Planning, Land Use and Mobility Committee

Case Report: **New Single Family Residence**
 DIR 2019-4606--DRB-SPP-MSP
21075 Topochico Drive.
 Woodland Hills, CA 91364

Project: Application for a Permit for construction of a 2-story, 2820 SF Single Family Residence and attached two car garage in the Girard Tract and the outer core of the Mulholland Scenic Parkway Specific Plan.

Updated rendering of rear (East) façade showing new balcony design, wood accents, new “Sand” coloration and downspouts to water retention barrels.

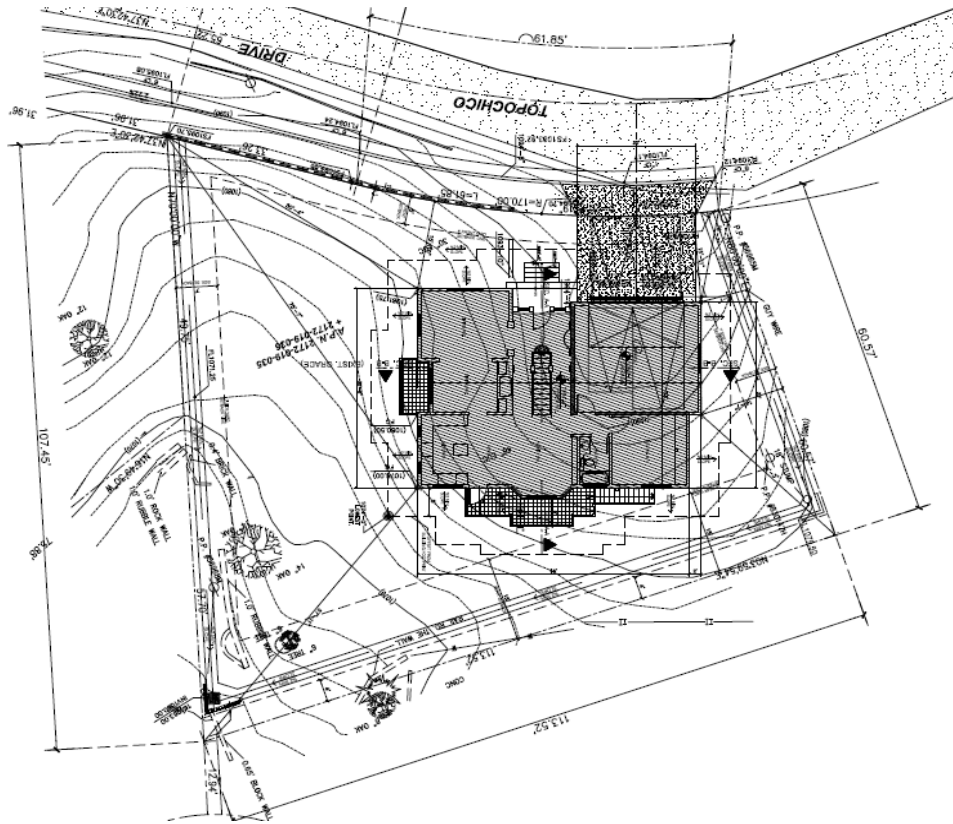
The Applicant has made significant changes to the exterior cladding of the proposed residence, by changing a dark gray coloration to a neutral “Sand” coloration, and has added architectural accents of wood cladding to highlight various window design treatments. The new colorations and materials appear to be in conformity with MDRB guidelines.

Site Plan for the proposed structure.

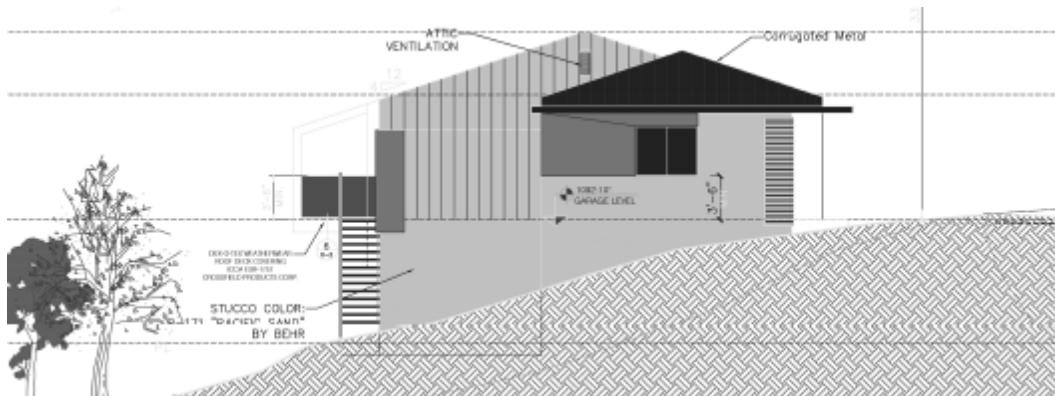
A requested staging plan, parking proposal, materials storage, and roadside berm are shown on last pages of this Case Report.
